- 5. Gruber Subdivision Ames Addition; KPB File 2024-046
Edge Survey & Design, LLC / Ames
Location: Stubblefield Drive
Kalifornsky Area**

**ITEM #5 - PRELIMINARY PLAT
GRUBER SUBDIVISION AMES ADDITION**

KPB File No.	2024-046
Plat Committee Meeting:	May 13, 2024
Applicant / Owner:	Brook and Gable Ames of Soldotna
Surveyor:	Mark Aimonetti and Jason Young / Edge Survey and Design LLC
General Location:	Stubblefield Drin Kalifornsky area / Kalifornsky APC

STAFF REPORT

GRUBER SUBDIVISION AMES ADDITION

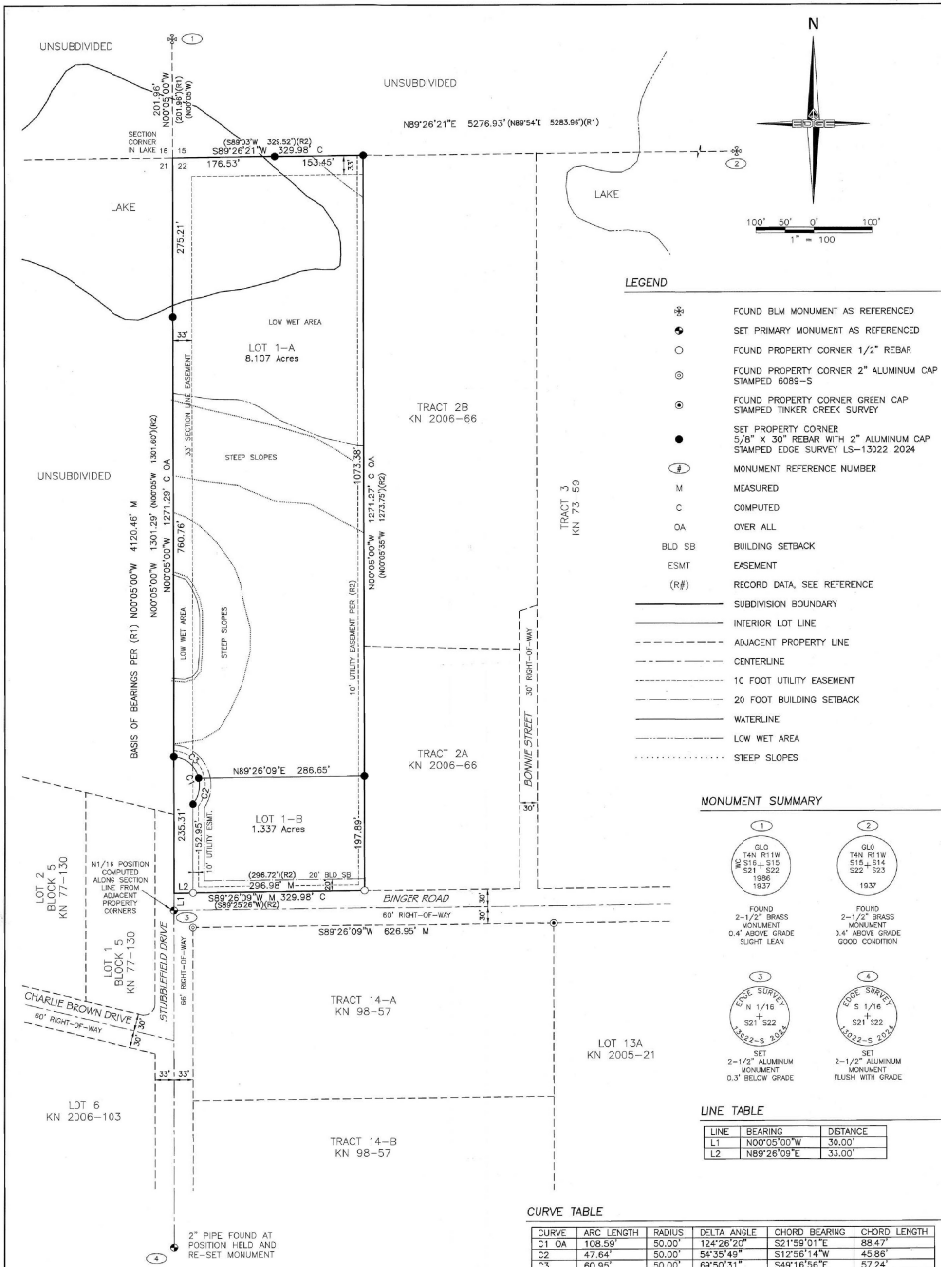
The subdivision is affected by a section line easement as shown on the drawing. The easement should be shown on both sides of the section line if they exist on both sides.

There are steep areas shown on the plat, identified as steep slopes. **Staff recommends:** the surveyor identify the

direction of slope with either an arrow or label top and toe.

HEA made comments as follows: the 10' utility easement listed as being by KN 2006-66 should be referenced to KN 72-59 on the east side of the plat.

Add KPB No 2024-046 to title block

- C. The location, width, and name of existing or platted streets and public ways, railroad rights-of-way, and other important features such as section lines or political subdivisions or municipal corporation boundaries abutting the subdivision;
Staff recommendation:
Show the temporary turnaround to the west from KN77-130

- D. A vicinity map, drawn to scale showing location of proposed subdivision, north arrow if different from plat orientation, township and range, section lines, roads, political boundaries, and prominent natural and manmade features, such as shorelines or streams;
Staff recommendation:
Label some of the prominent lakes on the map (eg. Echo Lake, Ashana Lake, Teack Lake, Leisure Lake, Reflection Lake, etc.)

- F. The location, width and name of existing and platted streets and public ways, railroad rights-of-way, easements, and travel ways existing and proposed, within the subdivision;
Staff recommendation:
Label the temporary turnaround shown on the parent plat

- G. The status of adjacent lands within 100 feet of the proposed subdivision boundary or the land status across from any dedicated rights-of-way that adjoin the propose subdivision boundary, including names of subdivisions, lot lines, block numbers, lot numbers, rights-of-way; or an indication that the adjacent land is not subdivided;
Staff recommendation:
Correct the plat label number to the east

- M. Approximate locations of slopes over 20 percent in grade and if contours are shown, the areas of the contours that exceed 20 percent grade shall be clearly labeled as such;
Staff recommendation:
Show direction of slope with an arrow or label top and toe

Add the date of May 13, 2024 to the Plat Approval
